Hard Shifting - 20/25 Tiller Handle Shift Models

1994¹/₂ and 1995 20/25 Tiller Handle Shift Models.

Figure 1. Components in Shift Kit

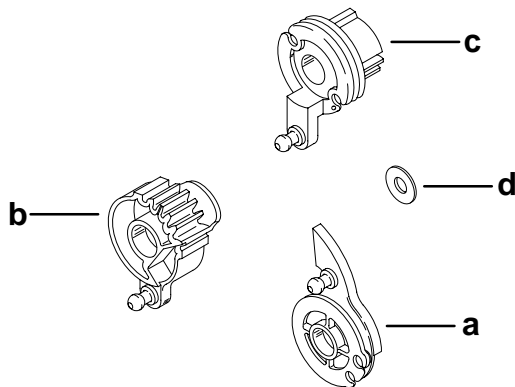
The tiller handle shift models listed above may exhibit hard shifting.

Primary and secondary gears are now designed with a greater number of teeth. The extra teeth incorporated into the new design offers an easier transition between gears and reduced shift load.

Service kit (P/N 823757A1) is currently available with the improved gear design. Shift kit components are shown below in figure 1.
